NFPA 13 Sway Brace Standards

Do Not Confuse With Other Bracing Standards

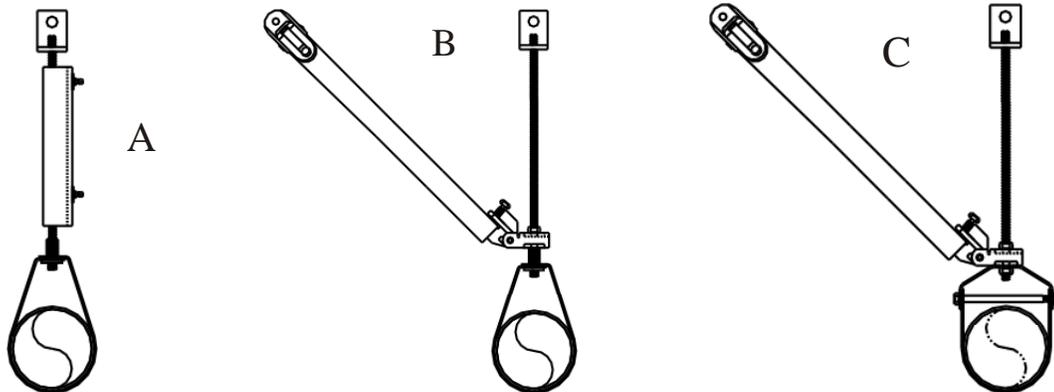
I have recently seen two sway brace installation details that are problematic to me. They are purported to be required in lieu of NFPA 13 sway brace criteria by other standards on fire sprinkler systems. The first detail requires installation of a stiffener on the hanger rod of a hanger assembly to resist vertical seismic force - see drawing A. The second details require installation of a lateral brace on the hanger rod of a hanger assembly to resist horizontal seismic force - see drawings B & C. I object to both of these sway brace details, as they do not conform to NFPA 13. They incorrectly promote the use of hanger components instead of sway brace components in NFPA 13 sway brace assemblies. NFPA 13 hanger components are listed per UL 203, while NFPA 13 sway brace components are listed per UL 203A. NFPA 13 and UL require installation of each component according to the differing characteristics unique to each of their individual product listings. If we scrutinize each of these assemblies per the NFPA 13 standard chapter 9 criteria it becomes evident that they are deficient.

In drawing A, this hanger assembly is not a sway brace per NFPA 13. The 2007 NFPA 13 chapter 9 hanging and bracing committee specifically rejected proposals to allow the use of a rod stiffener on a hanger assembly as a sway brace. The committee stated that vertical seismic force should be resisted with sway brace assemblies installed per NFPA 13 chapter 9. I would point out, that the hanger components shown are not listed per UL 203A as sway brace components as required by NFPA 13. Additionally, NFPA 13 fastener requirements for hangers are different than the fastener requirements for sway braces.

In drawings B & C, the lateral brace element attached to a hanger rod of a hanger assembly does not constitute a sway brace per NFPA 13. This assembly is not a sway brace because it does not conform to the following sections of NFPA 13 chapter 9. It violates "Bracing fittings and connections ...shall be listed." – per section 9.3.5.10.2 because the ring hanger is not a listed sway brace component per UL 203A. This assembly further violates chapter 9 criteria of "Sway bracing shall be tight." – per section 9.3.5.8.1 and "Bracing shall be attached directly..." – per section 9.3.5.11.1 as the ring geometry is loose and the brace element is not mounted directly to the sprinkler pipe per NFPA 13. Manufacturers who lack UL listed sway brace fittings for CPVC fire sprinkler pipe incorrectly promote this sway brace assembly contrary to the NFPA 13 standard and risk their reputation and integrity.

In my opinion, any recommendations, contrary to the NFPA 13 sway brace standard should be strongly resisted. Lacking agreement, I suggest the contractor request justification of the recommendation in writing.
